Great Bentley Parish Level Crossing Closure Proposal E45 – Great Bentley Station

Great Bentley Parish Level Crossing Closure Proposal E46 – Lord's Nr 1

MWL protection at local crossing E44

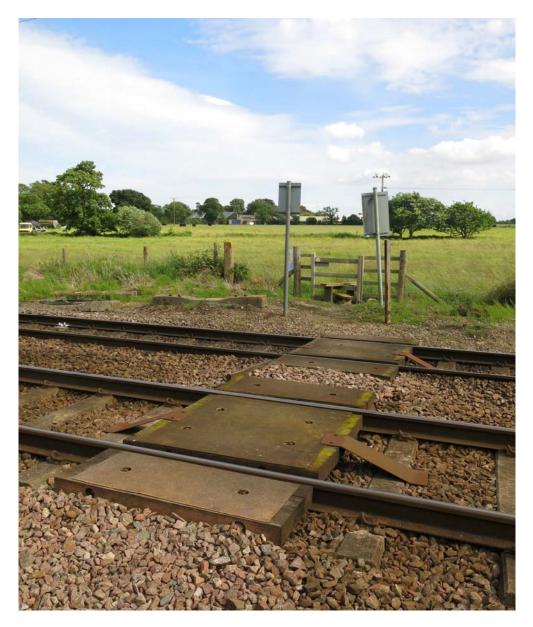
3. The sightlines at E46 are not limited but give good views in both directions. It is a quiet area and trains are readily audible. No accidents have been recorded at this crossing in the 150 years of its operation. Network Rail of course have the option of installing Miniature Warning Lights, as they have at E44, which would render this

crossing a Protected Crossing.
